SUBMITTAL REVIEW

Agency Name:	US General Services Administration
Project Name:	Chicago—Loop Station SSA Storage
Project Location:	211 S. Clark St., Chicago IL, 60604
BE No:	16034-17-03

Date Received:	06/09/2017	Specification Section:	Submittal 9-0051
Date Reviewed:	06/12/2017	Description:	Wire Mesh Partitions
Reviewer:	Michael Petti/James Auler

ELEVATION VIEW A

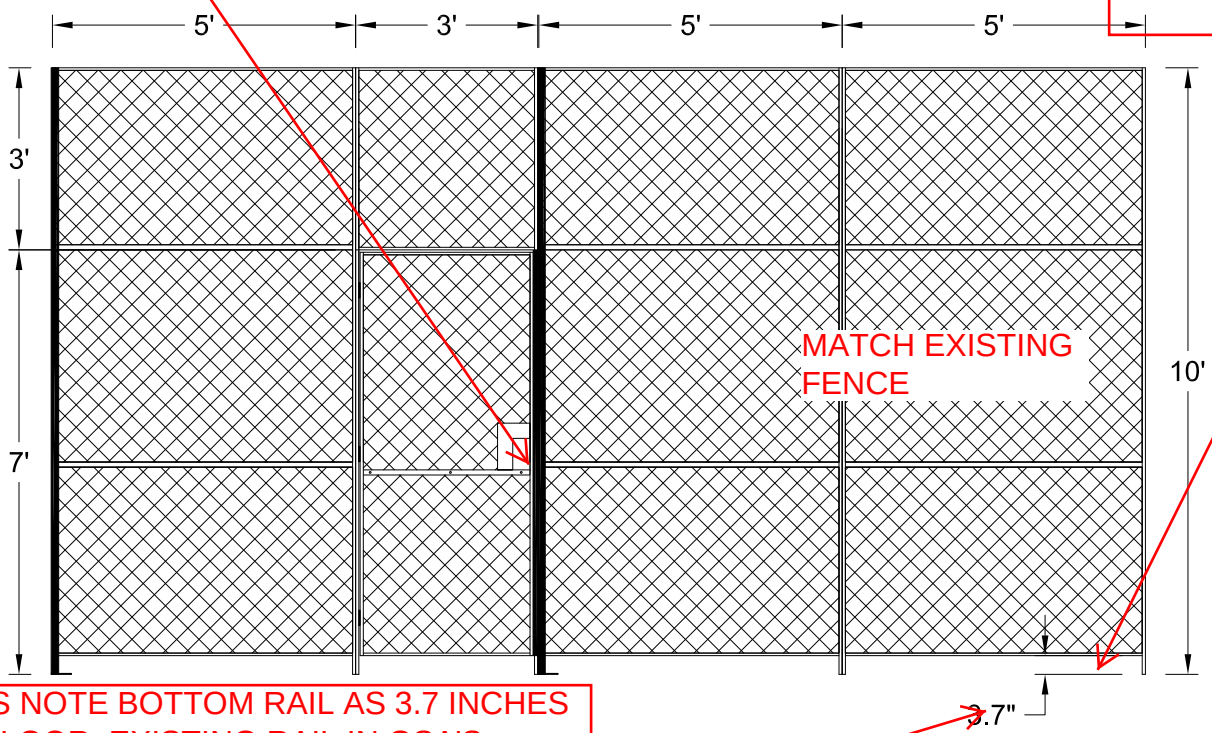
HARDWARE SHOWN NOT SPECIFIED. COORDINATE ALL LOCKING HARDWARE AND KEYING WITH THE GSA, AS REQUIRED, SEE NOTES, #3 AND #4, SHEET FP-1.

RAILS AND POSTS NOT IDENTIFIED. BOTTOM POST BRACKETS NOT IDENTIFIED. ANCHORAGE WITH 4 BOLTS NOT INDICATED. CONFIRM ALL MATCH EXISTING AS REQUIRED.

DRAWINGS NOTE BOTTOM RAIL AS 3.7 INCHES OFF THE FLOOR. EXISTING RAIL IN GSA'S PHOTOS, PAGE 4 OF 8, THE BOTTOM RAIL APPEARS TO BE ON TH FLOOR, OF VERY NEAR THE FLOOR. VERIFY WITH THE GSA THAT THE GAP SHOWN IS ACCEPTABLE FOR THEIR SECURITY NEEDS.

ELEVATION VIEW B

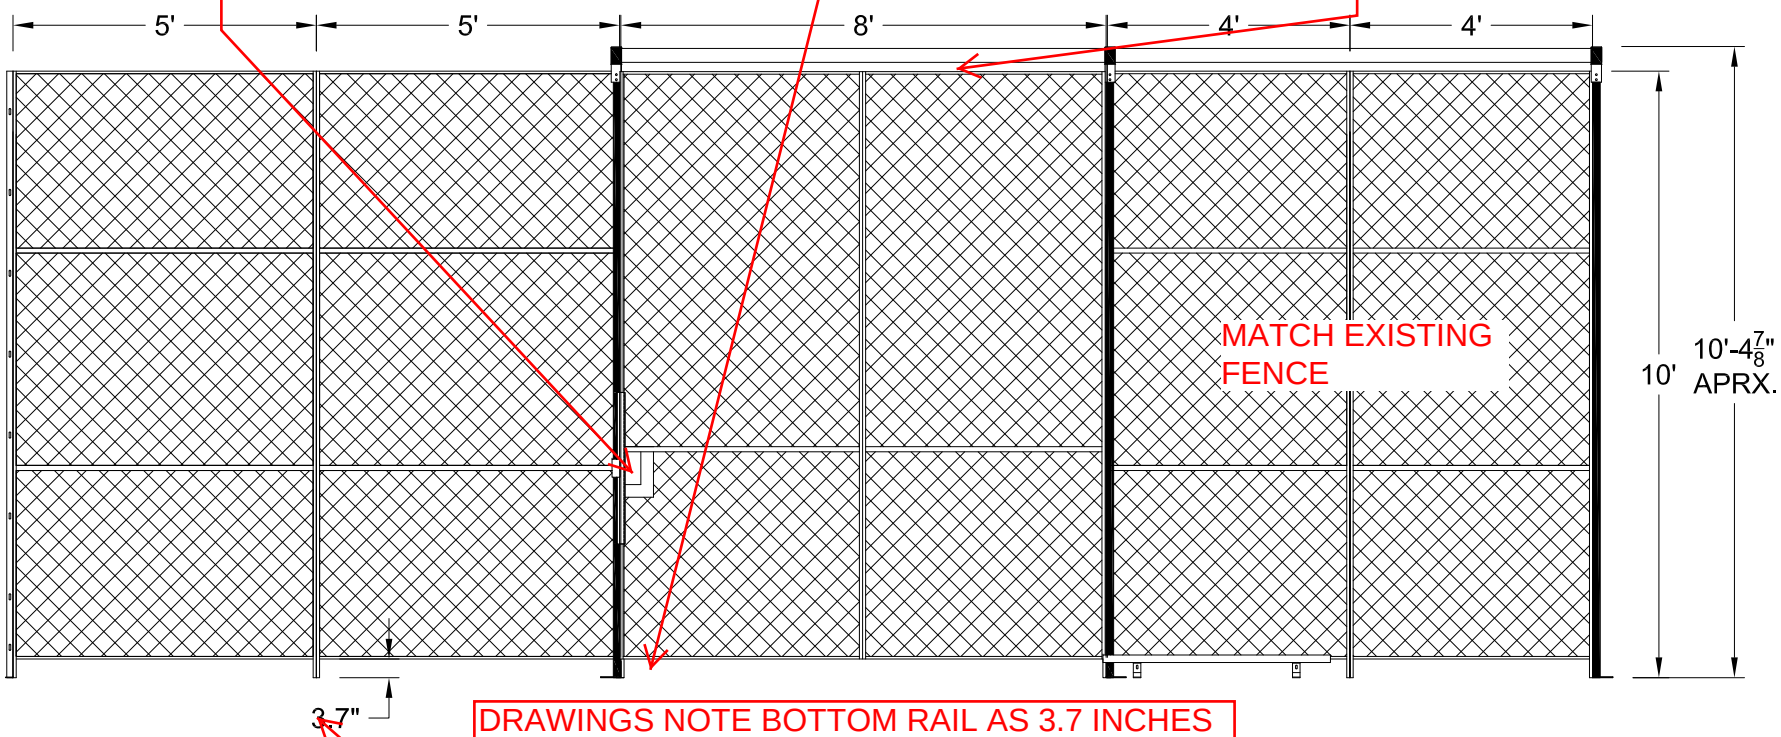
HARDWARE SHOWN NOT SPECIFIED. COORDINATE ALL LOCKING HARDWARE AND KEYING WITH THE GSA, AS REQUIRED, SEE NOTES, #3 AND #4, SHEET FP-1.

RAILS AND POSTS NOT IDENTIFIED. BOTTOM POST BRACKETS NOT IDENTIFIED. ANCHORAGE WITH 4 BOLTS NOT INDICATED. CONFIRM ALL MATCH EXISTING AS REQUIRED.

VERIFY OVERHEAD CLEARANCE

DRAWINGS NOTE BOTTOM RAIL AS 3.7 INCHES OFF THE FLOOR. EXISTING RAIL IN GSA'S PHOTOS, PAGE 4 OF 8, THE BOTTOM RAIL APPEARS TO BE ON TH FLOOR, OF VERY NEAR THE FLOOR. VERIFY WITH THE GSA THAT THE GAP SHOWN IS ACCEPTABLE FOR THEIR SECURITY NEEDS.
